SUBJECT: 50mm SSC Cable Size and Cross Section Status

This note is an attempt to update and clarify the information concerning the discrepancy between the insulated and uninsulated cable sizes spelled out in a note on 4-19-90. That note showed that the cable sizes derived from the W6733 cross section generated by Gerry Morgan (shown on Fermi dwg. #0102-MD-292000) were not in agreement with the cable sizes published by the cable manufacturers (Ron Scanlon). This happened because the cross section was created before the cable size was firmly established. The discrepancies in the outer were insignificant, but the inner totaled about 3 mils on the cable width. Specifically, the inner bare cable width being given by the manufacturer was .480 while the bare cable width assumed by the cross section was approx. .477. This was enough to put our mold and mandrel lamination drawings on hold while we waited for clarification.

Figure 1

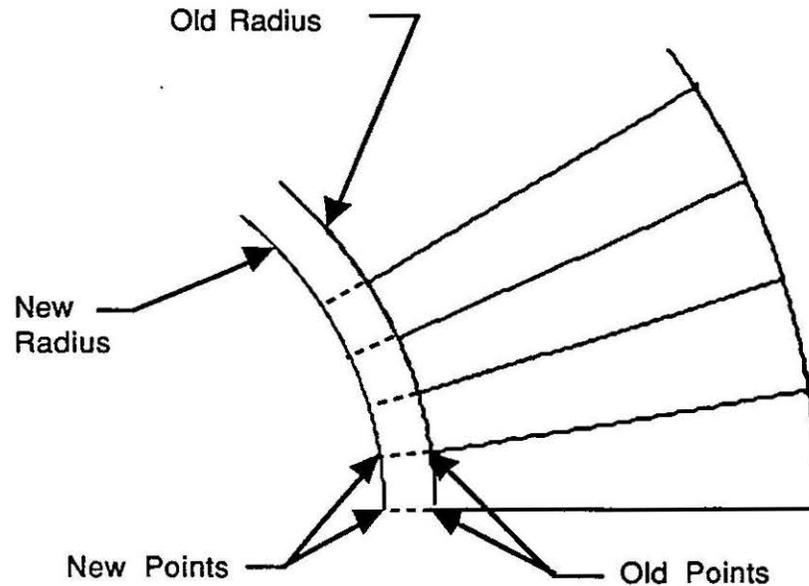
Concerning the cross section itself: All coordinate points for insulated cable corners stay the the same except the inner coordinates of the inner cable. These points will now be at the intersection of a circle of .9753 radius and the lines representing the sides of the present inner cables as shown in Figure 1. Cross section drawing #292000 should be changed to reflect this.

Outer coil outer radius = 1.9583 inches $\pm .001/-0.000$ (same as on 292000)
Outer coil inner radius = 1.4847 inches $\pm .000/-0.001$ (same as on 292000)
Inner coil outer radius = 1.4747 inches $\pm .001/-0.000$ (same as on 292000)
Inner coil inner radius = .9753 inches $\pm .000/-0.001$ (.009 less than on 292000)

Figure 2

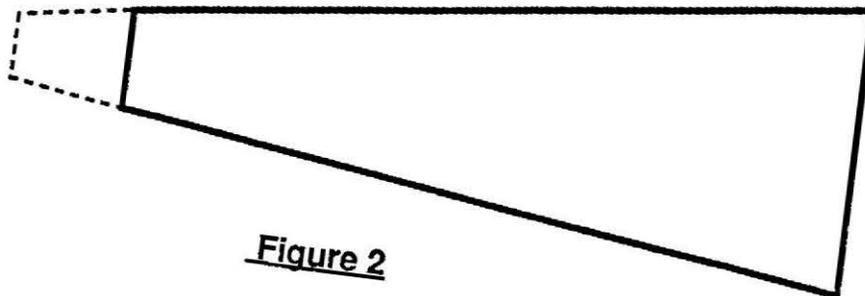
The cable width, however, will be increased in a way which is not entirely consistent with the way the cross section is being changed. In the cross section the keystone angle and high end thickness are being held while the low end thickness is allowed to change as shown in Figure 2. On the cable the high end and low end thickness are being held while the keystone angle is allowed to change as shown in Figure 3. This will result in the condition seen in Figure 4, where the cable insulation must compress more at the thin edge than the thick edge. The extra compression is on the order of .0001 per side, so the present thinking is to disregard it.
